Technical Note

Project No: ITB17593
Project Title: Carters, Caversham Road
Title: RBC Highways Response Note
Ref: JDW/ITB17593-003
Date: 11 January 2023

- 1.1 i-Transport LLP has been appointed by Bellway Homes (Thames Valley) Limited to provide highways and transport advice for a proposed residential development of 60 dwellings at Carters, 97a to 117 Caversham Road.
- 1.2 RBC provided an additional highways response in relation to the application on 16 December 2022. The full RBC response is presented at **Appendix A**. This technical note sets out a response to the request for clarification and proposed recommendations.

Image of footway along internal street

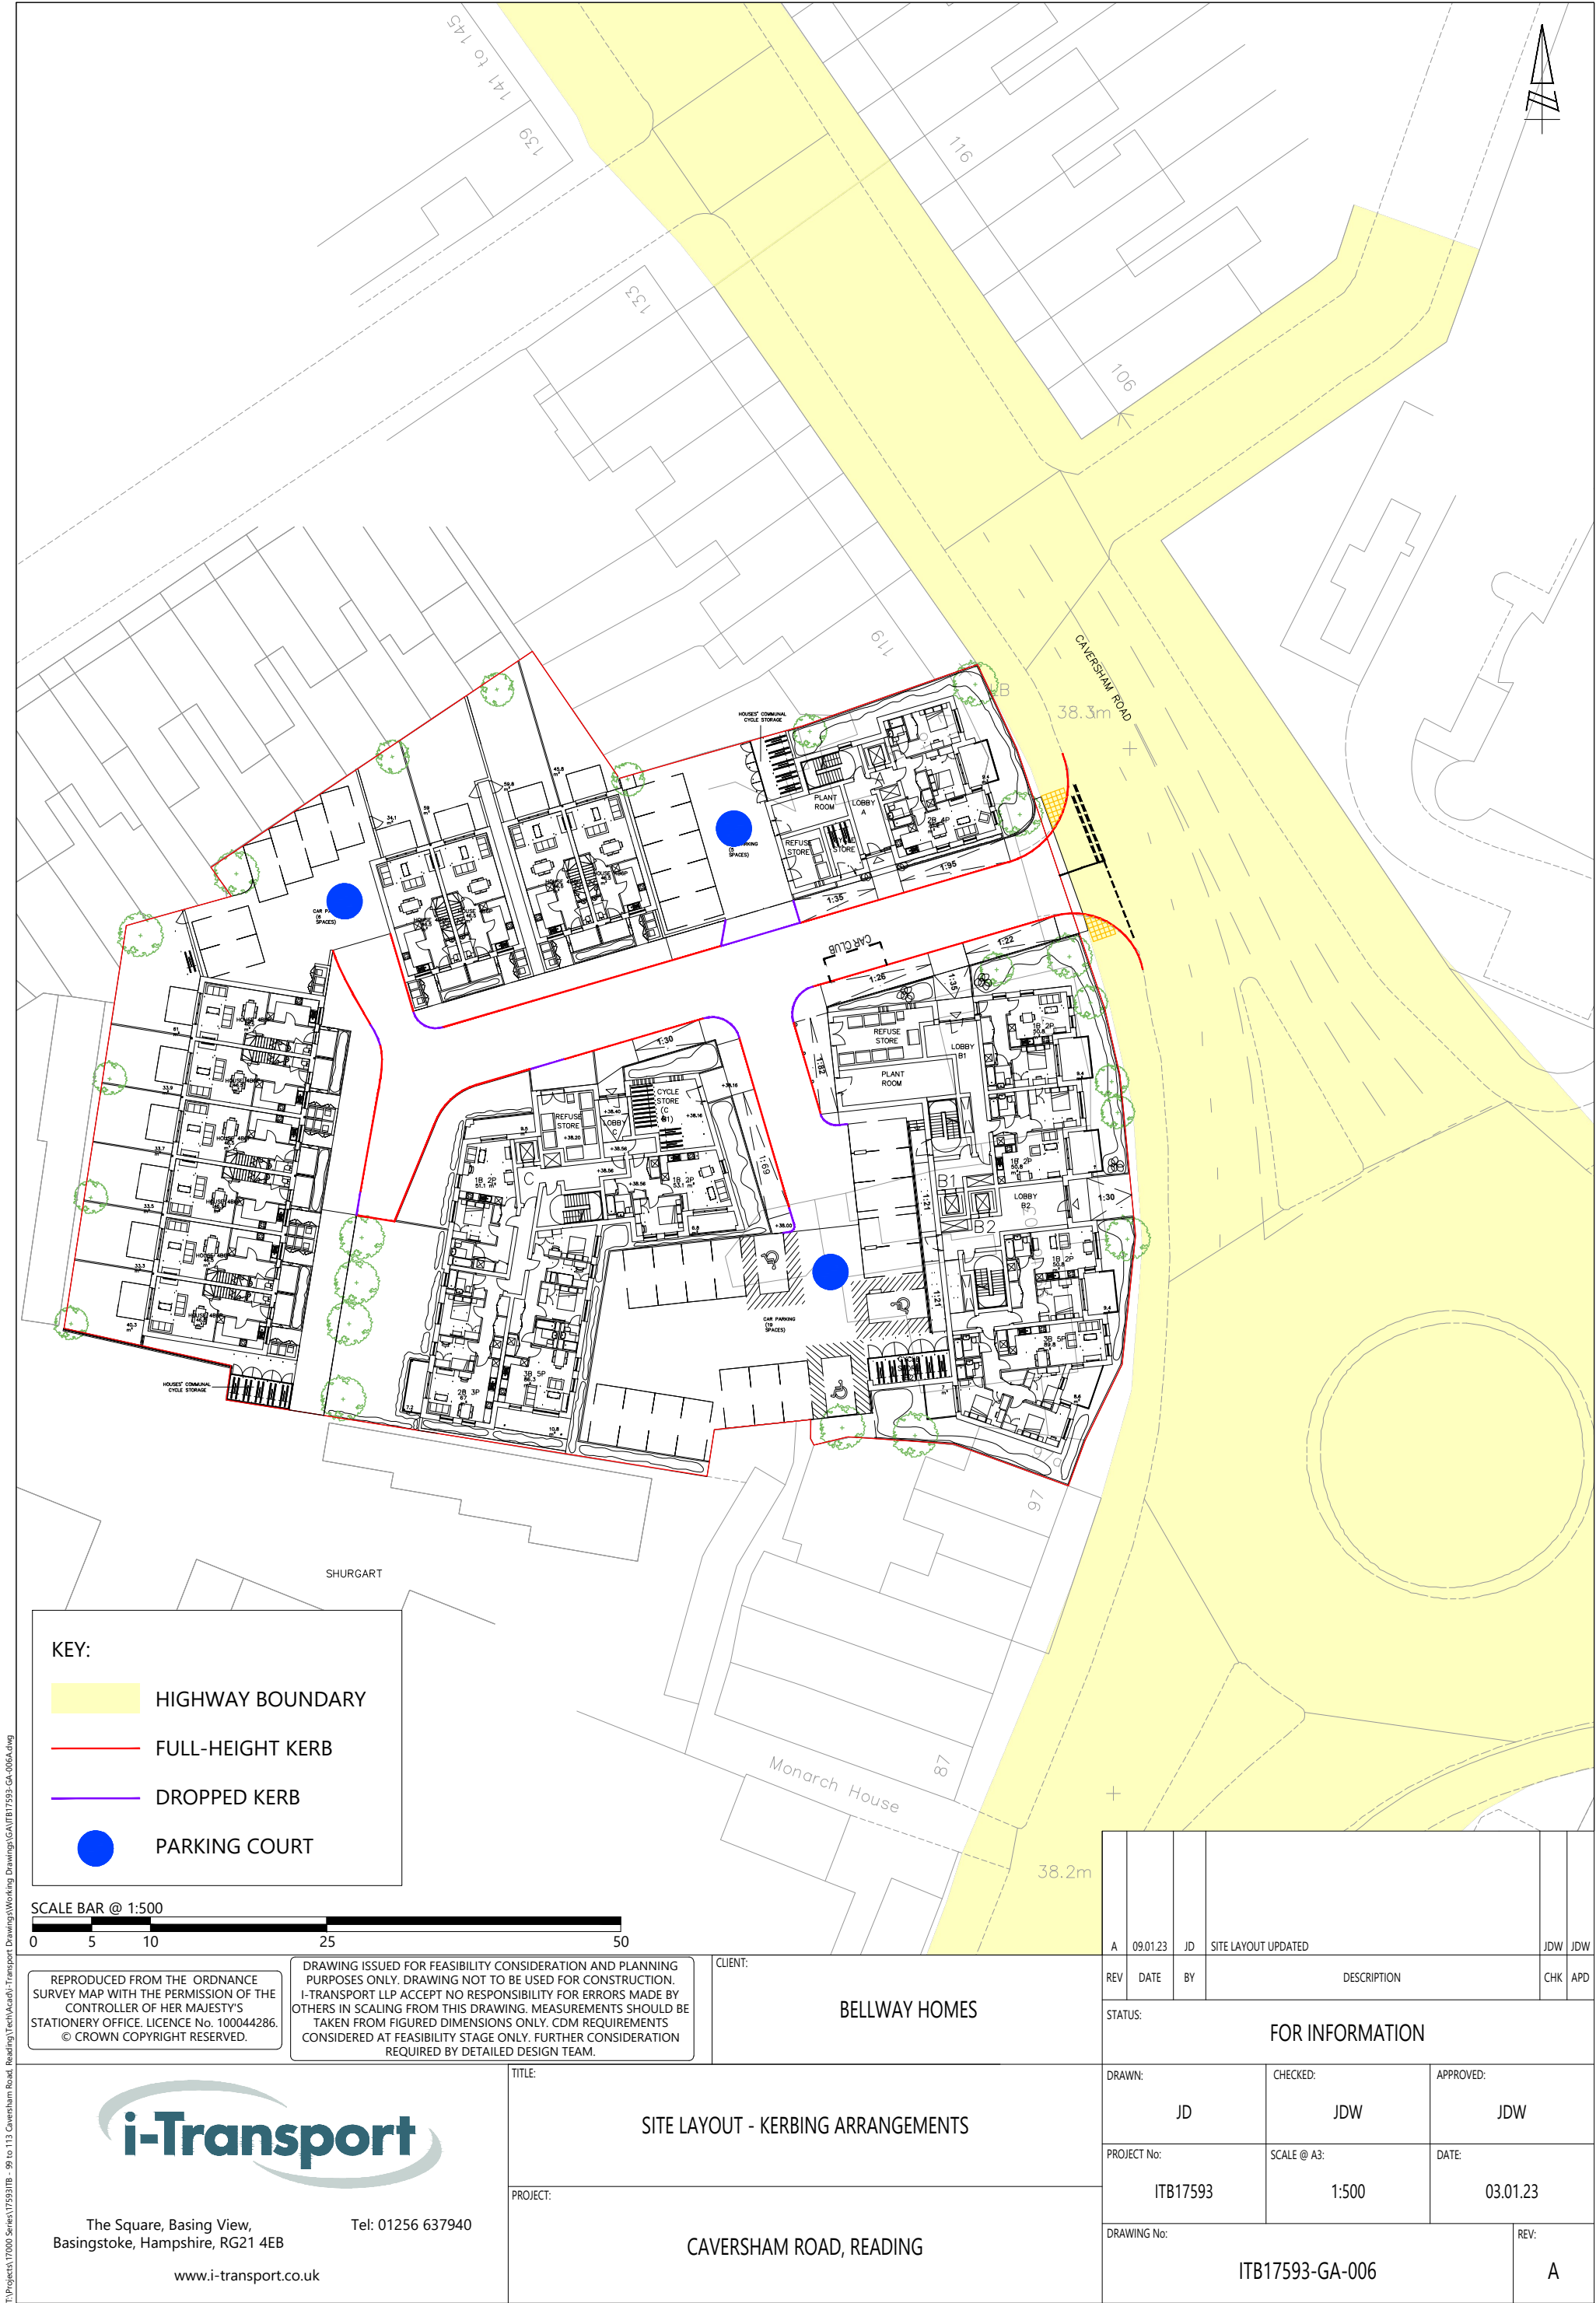
The Design Addendum updated view looking west along the new street towards the Central Block (block C) and the houses beyond does not illustrate a formal footway on the western side leading in from Caversham Road. This may be for illustrative purposes only but clarification is sought on this point.	The footway will continue along the length of the internal street. This has been updated on the plan CR-RMA-ZZ-00-DR-A-0100_P10 and in the images (see end of this report).
The revised Initial Site Access Arrangement (ITB17593-GA-001D) seems to illustrate some levels changes on the footways on either side of the carriageway. Therefore, can the gradient of the footways be confirmed.	Drawing CR-RMA-ZZ-00-DR-A-0100_P10, shows the proposed gradient of the footways. All gradients are acceptable for all modes.
There appears to be an excessively wide break in the footway provision to allow access to a parking area between Block A and the semi-detached dwellings, therefore, the footway should be extended along the length of the brick wall (of the parking area) and provided with dropped crossings.	As requested, the footway has been extended along the length of the street, with a drop kerb crossing into the parking court being provided.

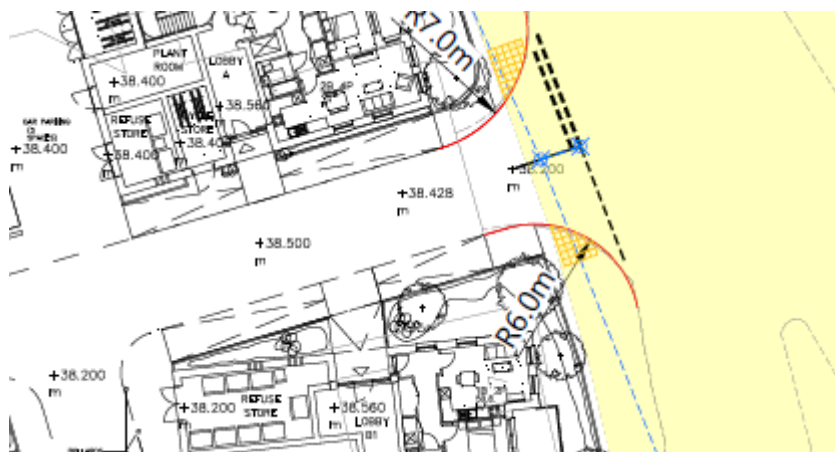
The site access road would have a width of 5.5m, with dedicated 2.0m wide footways leading into the site which accords with Readings Geometric Design Guidance. The drawing titled Initial Site Access Arrangement (ITB17593-GA-001D) illustrates the proposed junction improvements including tactile crossing points on Caversham Road for pedestrians.

However, in order to comply with the Readings Geometric Design Guidance, the junction radii for residential accesses onto main transport corridors should be 10m. If the applicant proposes a smaller radii as illustrated in the Site Access Arrangement, then the tracking diagram should be submitted which shows a refuse vehicle entering the site without crossing the centre line of the junction. The Swept Path Analysis (ITB17593-GA-002 Rev E) shows a refuse manoeuvring within the site and exiting the site, but it does not illustrate a refuse vehicle making a left-hand turn from Caversham Road into the site. Given the proximity of the Caversham Road/Vastern Road roundabout, service vehicles must be able to enter the site without obstructing the flow of traffic on the classified road network.

RBC Comment	i-Transport Comment
....in order to comply with the Readings Geometric Design Guidance, the junction radii for residential accesses onto main transport corridors should be 10m. If the applicant proposes a smaller radii as illustrated in the Site Access Arrangement, then the tracking diagram should be submitted which shows a refuse vehicle entering the site without crossing the centre line of the junction. The Swept Path Analysis (ITB17593-GA-002 Rev E) shows a refuse manoeuvring within the site and exiting the site, but it does not illustrate a refuse vehicle making a left-hand turn from Caversham Road into the site. Given the proximity of the Caversham Road/Vastern Road roundabout, service vehicles must be able to enter the site without obstructing the flow of traffic on the classified road network.	A conscious decision was made to keep the junction as tight as possible, to reduce the distance pedestrians have to cross at the access, and to replicate the existing access arrangements. Drawing ITB17593-GA-002 has been updated to illustrate a refuse vehicle making a left-hand turn from Caversham Road into the site. This shows that a service vehicle is able to enter the site from Caversham Road/Vastern Road roundabout, without obstructing the flow of traffic on the classified road network, even if a vehicle is waiting to turn out of the site.
